TRANSMITTAL LETTER FOR THE REGULATORY COMMITTEE REPLY TO STATE OF NEW  
JERSEY DEPARTMENT OF ENVIRONMENTAL PROTECTION COMMENT ON  
UNDERGROUND STORAGE TANK REMEDIAL INVESTIGATION FOR GROUP II SITES NWS  
EARLE NJ  
6/21/1996  
BROWN AND ROOT ENVIRONMENTAL

Subject:       Underground Storage Tank Remedial Investigation Report for Various Sites (Group II)  
                  Naval Weapons Station Earle  
                  Colts Neck, Monmouth County

Response to Comments:

**FIGURE 2-2**  
**Building C8/02 UST Location Map**  
**Naval Weapons Station Earle**

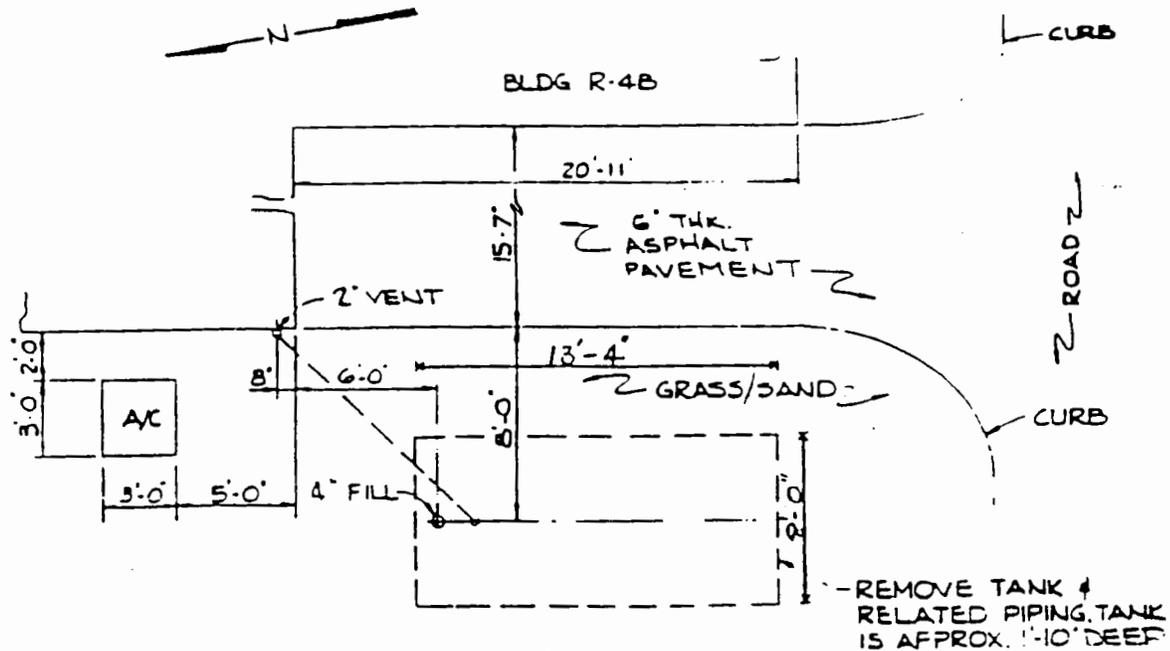
3. The location of the UST excavations as indicated in the RI Report represents B&R Environmental's best estimate of the location of the former USTs, based on site conditions and the information in the Closure Reports. The Closure Reports were prepared previously by another Navy subcontractor. Refer to Attachment A for a copy of UST location documentation as indicated in the Closure Reports for Buildings C-8, R-4B, and R-11. Note that drawings or maps that indicate the locations of the USTs and the post-excavation samples at Buildings C-28 and 617 were not included with the closure documents.
4. Sample locations during the RI were measured in the field based on fixed references (such as building corners) and plotted on scaled site maps that were included in the RI Report. Copies of the field log book indicating field measurements are included in Attachment B.

**BUILDING 566**  
**UST AND LEACHFIELD PROPOSED INTERIM REMEDIAL ACTION**  
**NWS EARLE, NEW JERSEY**

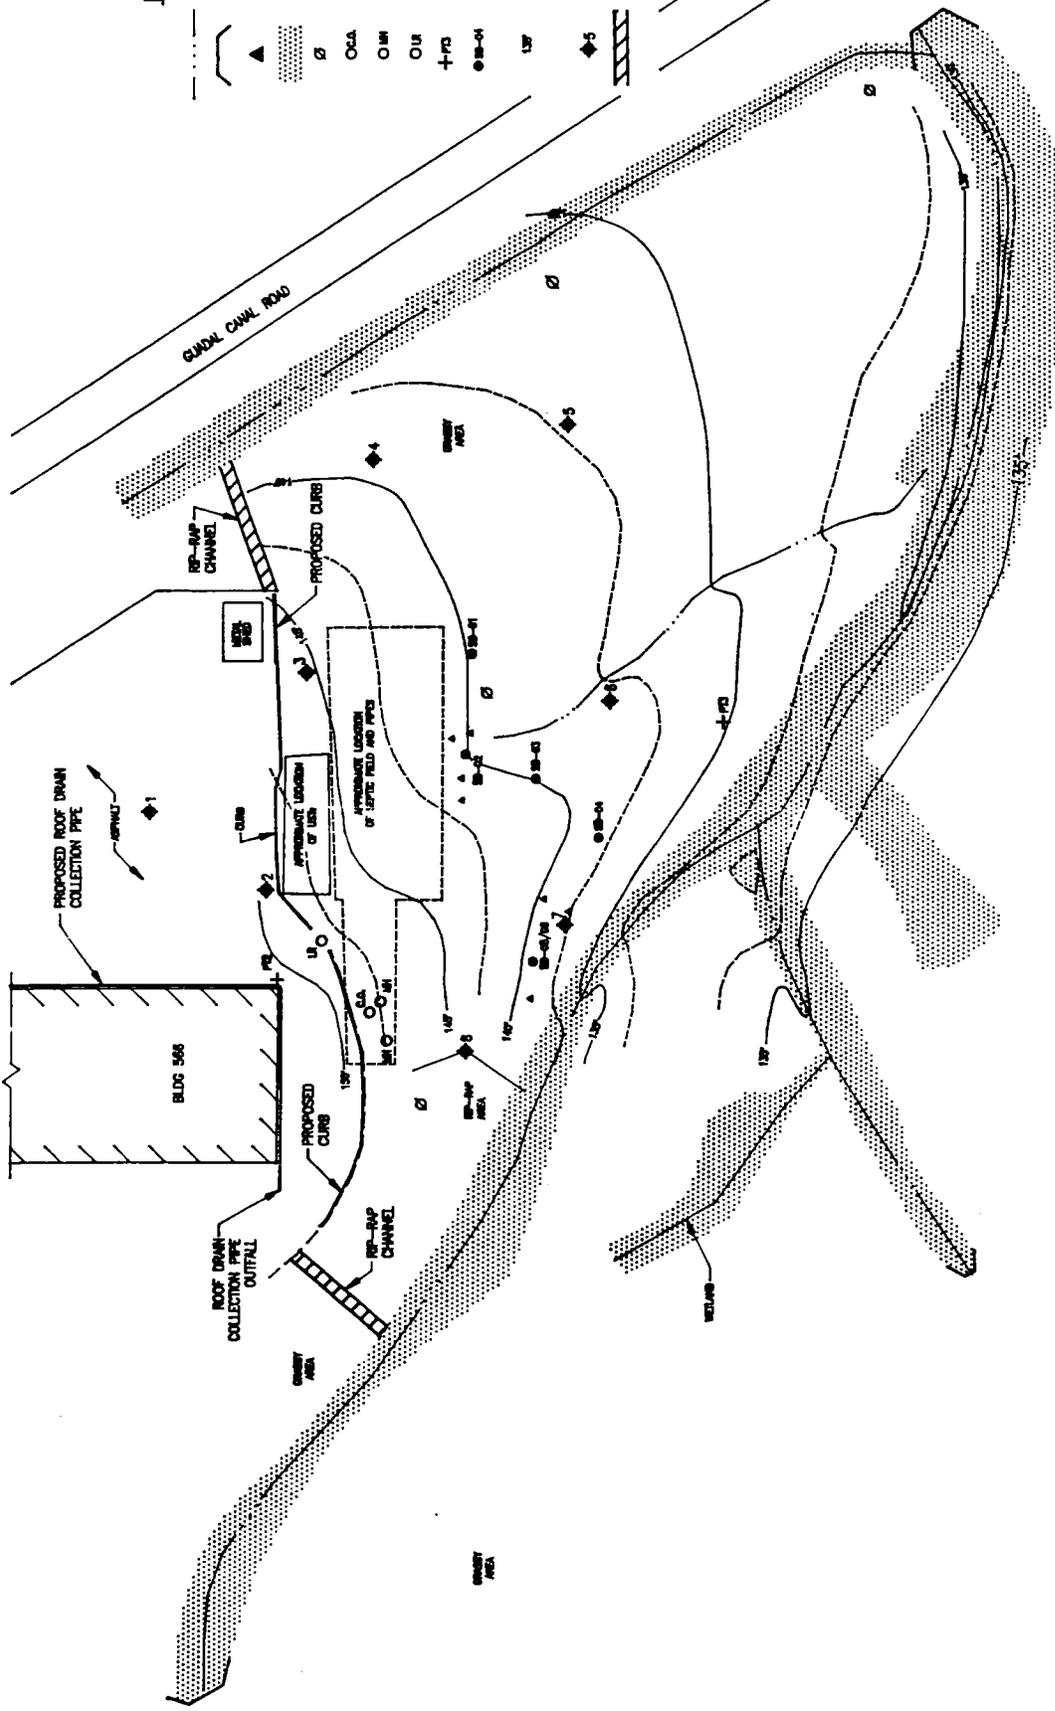
The interim action planned for Building 566 is detailed in a letter report dated October 11, 1995, from B&R Environmental to Mr. Brian Helland, Naval Facilities Engineering Command. This letter is included for review in Attachment C.

2. Install piezometers upgradient of the USTs and downgradient of the septic leach field. The piezometers or monitoring wells should be installed using "push-point" methods. A minimum of seven piezometers will be required. Figure 1 shows the proposed location of the piezometers.
